Technical Memorandum

Re: Area 3 Minnesota Riverbank Stabilization Project Update

Memorandum

To: Della Young, Katy Thompson – Young Environmental
From: Tom MacDonald, Brent Theroux
Subject: Review of Area 3 Alternatives
Date: July 1, 2021
Project: Area 3 Lower Minnesota River Watershed District
c: Karen Chandler, Katie Turpin-Nagel – Barr Engineering

Figure 1: Concept alternative planview.

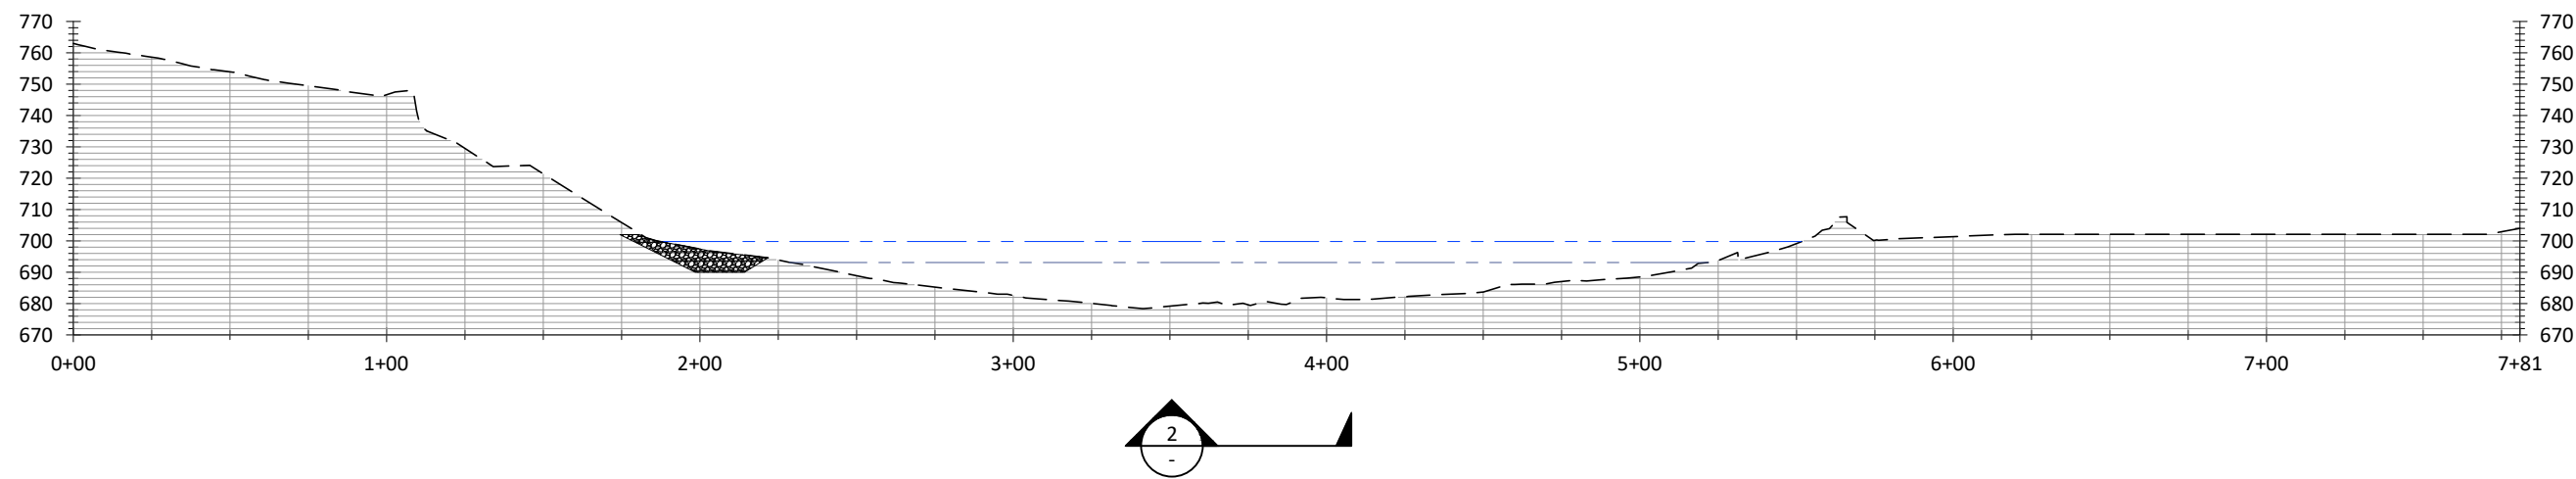
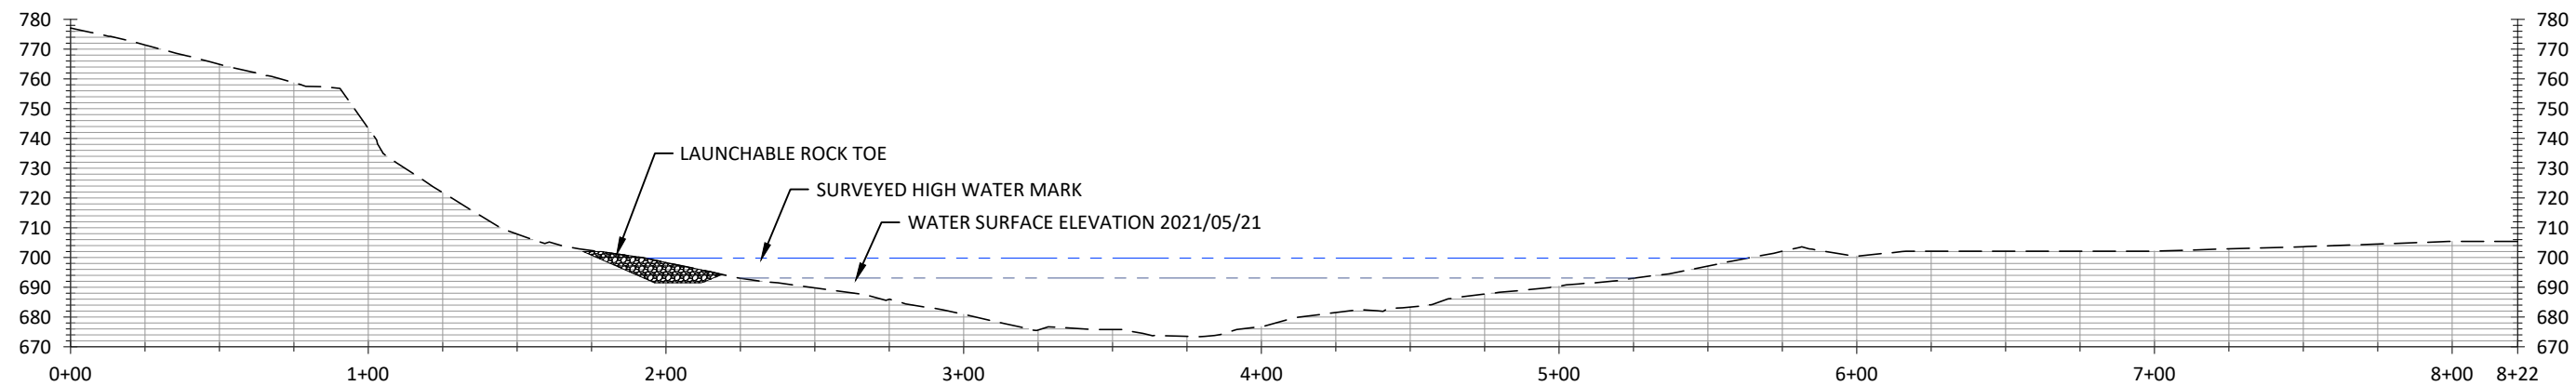
- Concur
- Conceptual Alternative 1: We are skeptical that Class II riprap would hold up as bank armor in the long term.

5. Self-launching riprap may not be a worthwhile option; it may not launch in a manner that protects against future toe erosion, and the protection may be short-lived.

Figure 2: Concept alternative 1 typical cross-section estimated Q2 scour depth rock volume.

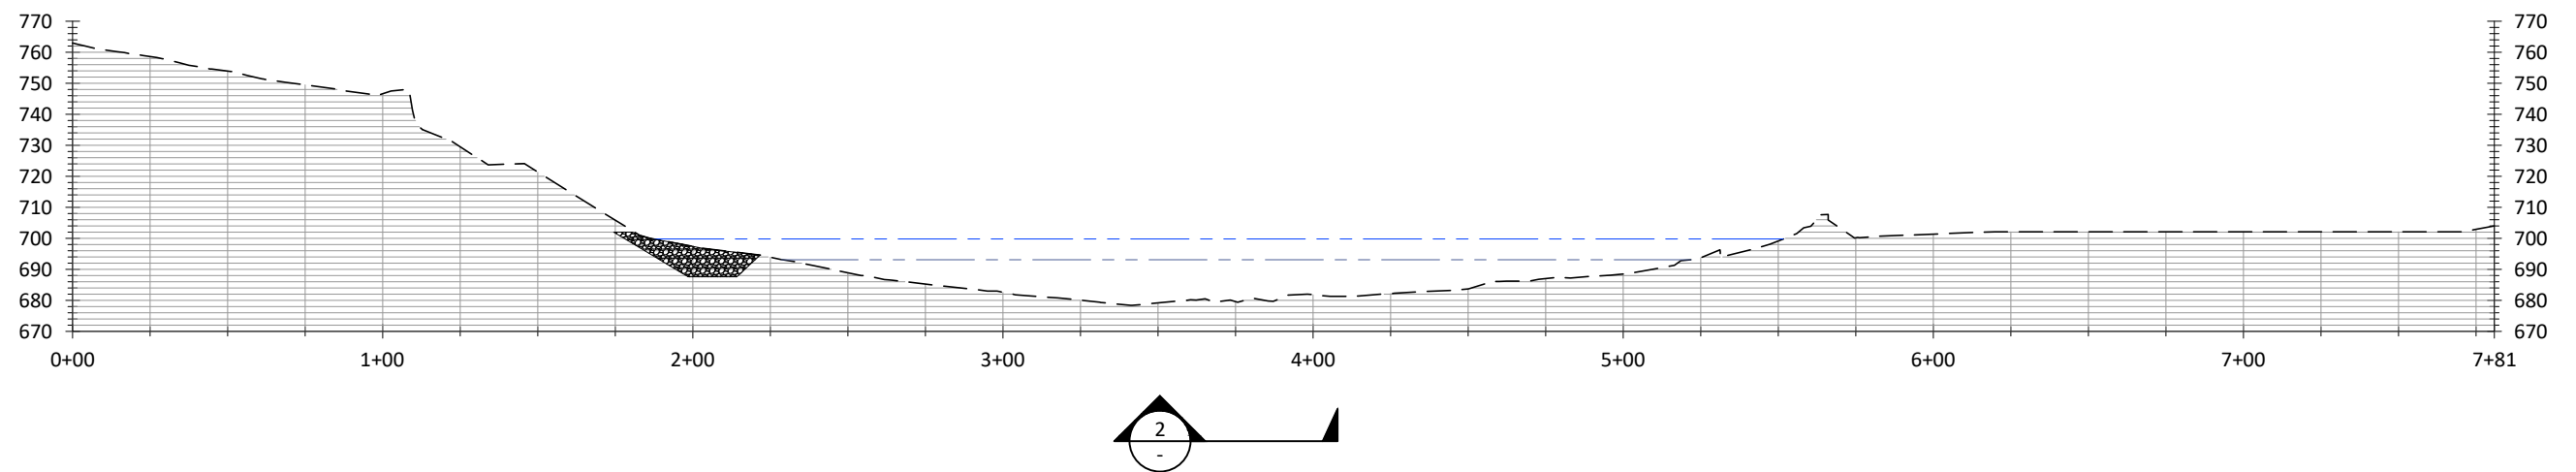
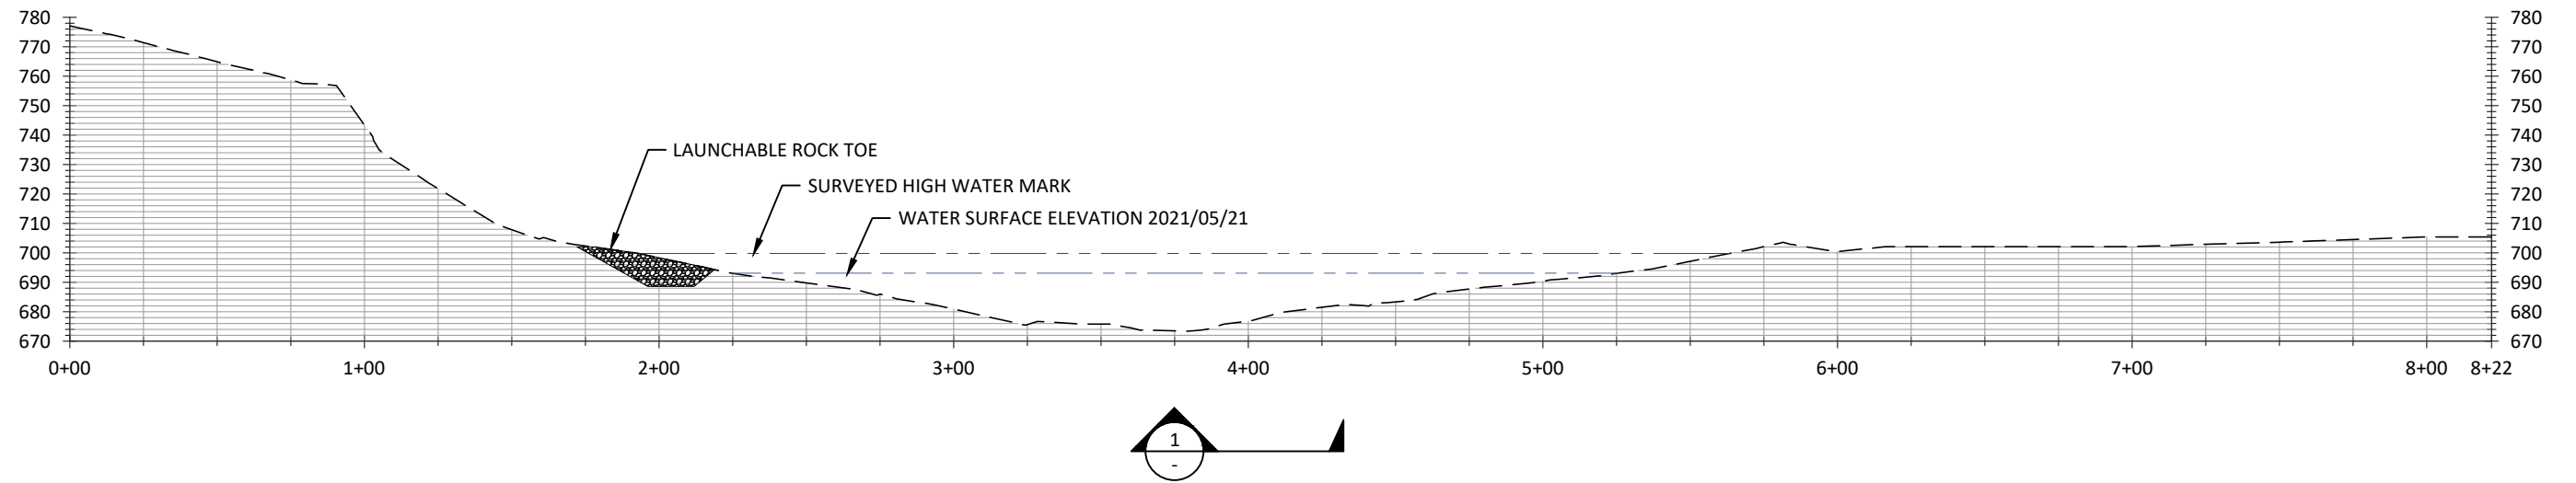
- Cost estimates should elaborate on assumptions for mobilization, access/staging, erosion/sediment control, limits of disturbance, permitting, and surface fabric.

- Qualifies that Conceptual Alternative 1 would not prevent future mass wasting events. It would only prevent northern migration of the channel.
 - Concur
- Toe (sediment) entrainment and river migration are not presently contributing to bluff erosion, but could in the future depending on precipitation patterns and river flows.
 - Concur
